EGR System – Deleted on North American Specification (NAS) XK8 VehiclesMODEL 1997 MY-ON
XK8 Range
VIN
011462-ON

Remove and destroy Bulletin 303-07, dated 5/97.
Replace with this Bulletin.
Revisions are marked with a bar and in **bold text**.

ILLUSTRATION 1

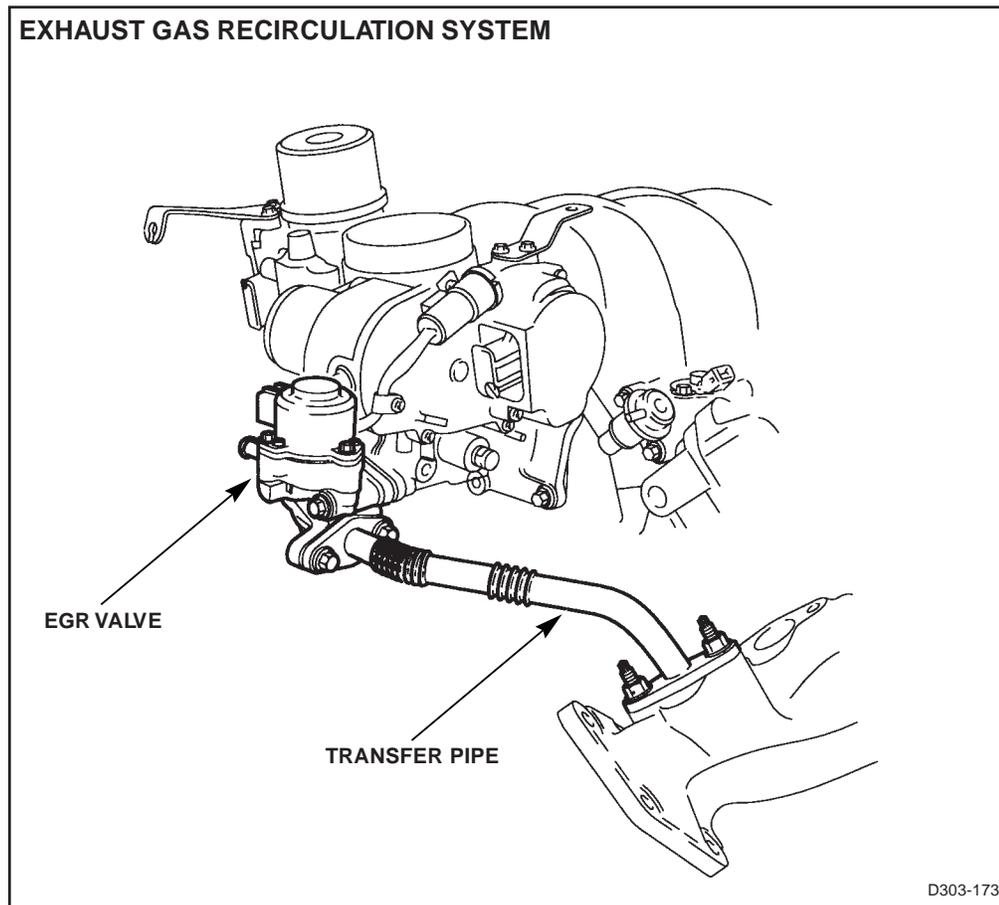
The EGR system (Illustration 1) has been deleted on NAS XK8 models beginning with VIN 011462. Vehicles with or without EGR can be equipped with the latest ECM part no. LJA 1410CA/*** which replaces LJA 1410AN/***.

*** = 010 for USA,

*** = 012 for Canada
